LANDSLIDE HAZARD DEVIATION

Project: **Point Wells Urban Center**

Request: **Landslide Hazard Deviation from SCC 30.62B.340 [2007]**

Date of Decision: **May 14, 2020**

Figure 2 – Image 1 of Exhibit K-16 (Highlighting of Sounder Station Added)

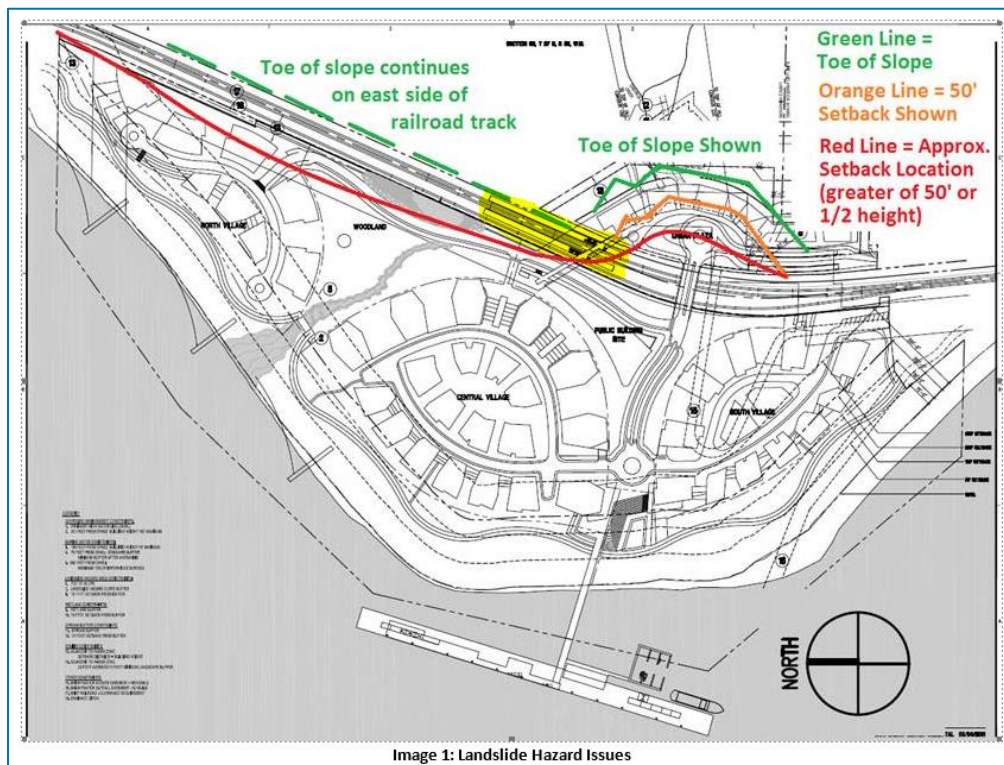
Finding No. 10: Also with regard to the potential to locate the Sounder station at an alternate location outside of the Landslide Hazard Area, the Applicant has not provided information to ascertain what lesser setback might be appropriate in the southern portion of its project site. The County provided the Applicant prior notification of this deficiency (see for example, Exhibit K-16). Image 1 in Exhibit K-16 represents the County's Illustration, through a marked up version the Applicant's original 2011 plans (specifically, Sheet A-051 of Exhibit B-2) of a code compliant setback based on publicly available contours. **Figure 2** reproduces Image 1 of Exhibit K-16 below, with the addition of yellow highlighting on what was the Applicant's previously-proposed location of the Sounder station. Comparing Sheet A-051 of the original plans (Exhibit B-2/Figure 2) to the same sheet in the most recent 2019 plans (Exhibit V-6), the Chief Engineering Officer notes that the secondary bridge and proposed Sounder station have moved northward (left), which is placing the development further into the Landslide Hazard Area. The location of the southern bridge across the tracks has not materially changed between iterations of the project and, based on **Figure 2**, this location may be outside the Landslide Hazard Area. The Applicant has provided no evaluation or explanation why the Sounder station could not be located under the southern bridge and potentially outside, or at least partially outside, the Landslide Hazard Area as required by SCC 30.62B.340(2)(b)(i) [2007].

Conclusion No. 4: For the purposes of SCC 30.62B.340(1) [2007] and SCC 30.62B.340(2)(b)(i) [2007], the Applicant has **failed to demonstrate** that there is no alternate location for the **Sounder Station**.

Figure 3 – Highlighted SDMH Shown as a Catch Basin with Reversed Elevations
(Adapted from Sheet C-300 of Exhibit V-6)

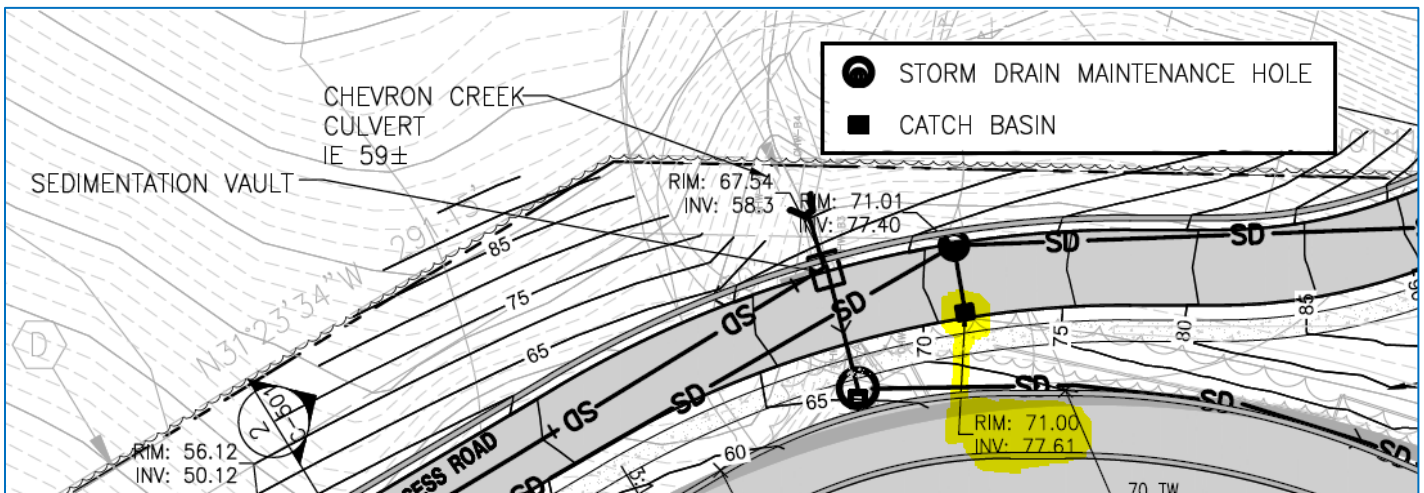
Finding No. 31: The additional requirement in SCC 30.62B.340(3)(e) [2007] relates to conditions when construction of utilities in Landslide Hazard Areas is permissible. The Applicant’s materials conflict with SCC 30.62B.340(3)(e) [2007] requirements for construction of utilities in Landslide Hazard Areas, in part, based on utility construction details that conflict with EDDS. In addition to these conflicts, there are many further drafting errors of concern. Both of the catch basins from in **Figure 3**, below, are from Sheet C-300 of Exhibit V-6 and illustrate these issues. First is a drafting error that applies to both catch basins. For the highlighted catch basin, the plans give a rim (top) elevation of 71.00’ and an invert (bottom) elevation of 77.61’. Top elevations should always be higher than bottom elevations, but of these catch basins are in reverse. Several other catch basins in the C-series plan sheets also appear with bottoms higher than the tops, all of these would require correction. Second, is a conflict with EDDS 5-07(B)(2) which requires cleanouts deeper than five feet to be either a Type-2 catch basin (or a manhole) rather than a standard Type-1 catch basin. Plans must depict Type-2 catch basins as “Storm Drain Maintenance Holes” (or SDMH’s) rather than as simple “Catch Basins.” Assuming the elevations on the highlighted catch basin were merely backwards, then it should have been depicted as an SDMH (a rim of 77.61’ and an invert of 71.00’ = a 6.71’ deep cleanout that should appear as an SDMH). The C-series plan sheets show many other catch basins deeper than five feet. All of these should appear as SDMH’s. The figure also shows an SDMH with similar (and also reversed) elevations as the highlighted catch basin, but with the correct symbol. Also, note that the rim elevation shown for the sedimentation vault is not clear. However, a nearby label shows the rim higher than the invert, which would be correct. Finally, the pipe between the two catch basins has a reverse slope causing water backup and failing to comply with EDDS requirements.
